81101A-06B

S E R V I C E N O T E

81100 Family Pulse Pattern Generators

**Intermittent display failures
(shifting lines, inverted, fully lit or completely dark display)**

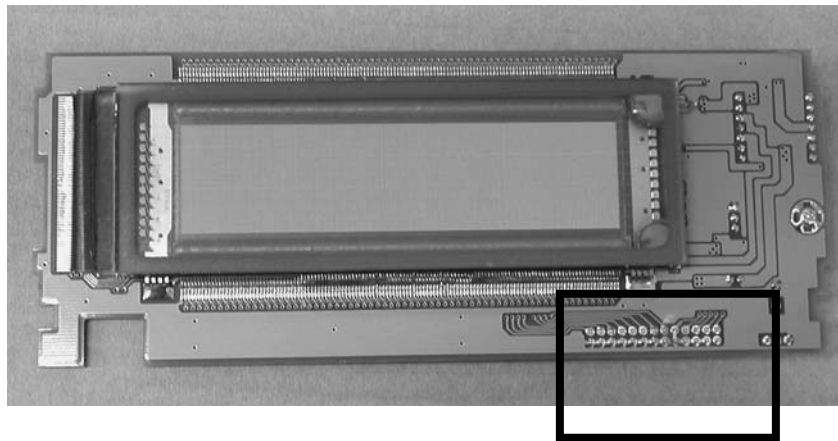
Intermittently the front panel display may show shifting lines that are falling back to their normal state. Additionally an inverted display, a display with all pixels lighted or a blank display may occur intermittently.

- Remove the front frame and unplug the connector cable from the 81100 mainframe.
- Carefully remove the display module from the front frame and check for a capacitor that might have been added during an earlier intermittent modification (see picture below). If there is such a capacitor, unsolder it from the module. Re-install the display into the front frame.

- On the 81100 mainframe replace the existing filter plate with the new filter plate, p/n 0960-0996. The new filter plate can be identified by a single connector pin that shows a red color code.
